# PARRAMATTA LIGHT RAIL (STAGE 1)

### Environmental Impact Statement

City of Parramatta Council  
Submission to the NSW  
Department of Planning and  
Environment

November 2017

Figure 1: Potential road widening requirements as a result of Gasworks Bridge duplication

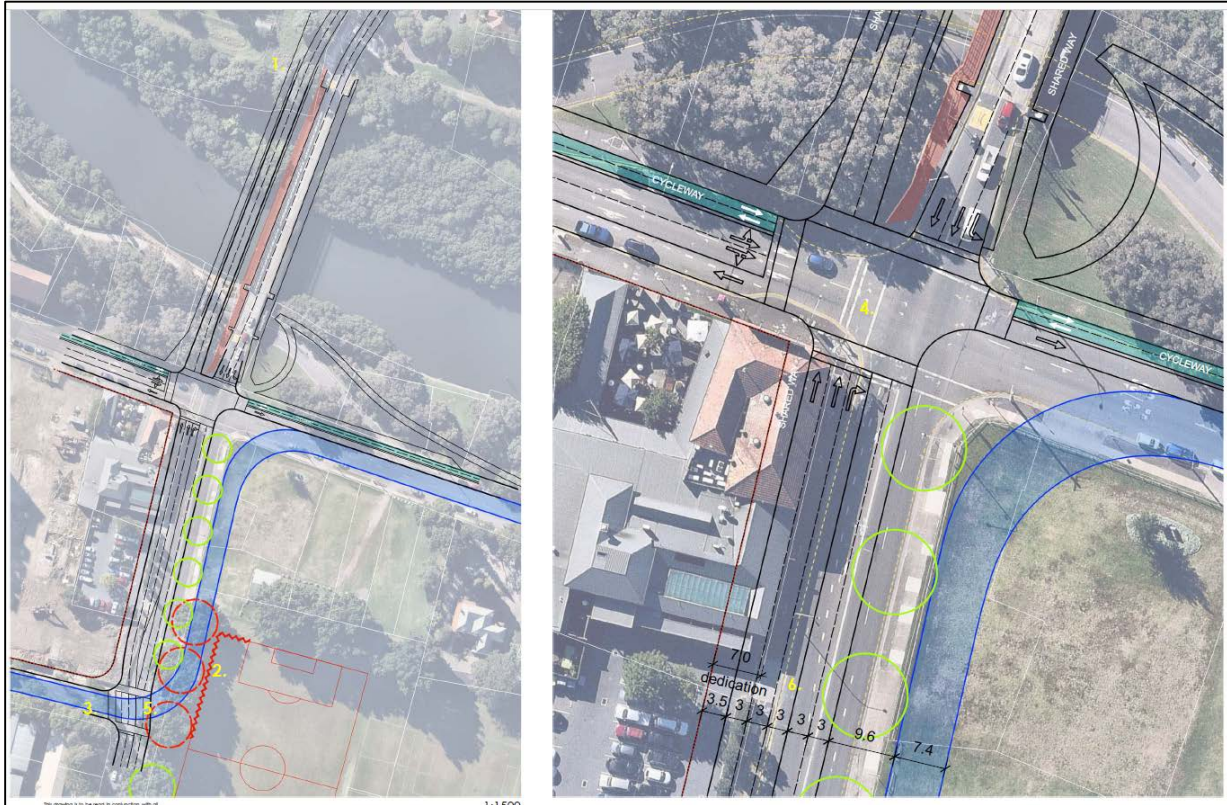
The results of the traffic modelling show high levels of congestion on the north western part of the Inner Ring Road. This may then result in traffic diverting to other parts of the Inner Ring Road including Gasworks Bridge. The existing Gasworks Bridge has a limited, although currently unknown lifespan. The Project will also limit the options for Council's proposed widening of Gasworks Bridge. The current design allows widening of the bridge on the west side of the existing bridge. This results in a requirement to use part of MacArthur Girls High School and the hotel site on the south west corner of the intersection of George Street and Harris Street. A bridge widening on the west side means that the existing bridge is used for southbound traffic. This means that it is less likely that a right turn into George Street could be provided as part a

bridge widening, because the existing bridge is only 2 lanes wide, whereas a future bridge for southbound traffic could be 3 lanes wide.

As highlighted in Figure 1 below, a widening of Gasworks Bridge will require additional road widening along Harris Street, together with the Light Rail, and therefore will result in a distance of 35.5 metres from the western footpath to the eastern edge of Robin Thomas Reserve. Council has concerns that the widening of Harris Street will result in alienation of the western edge of the Robin Thomas Reserve, the only active playing fields in the Parramatta CBD.
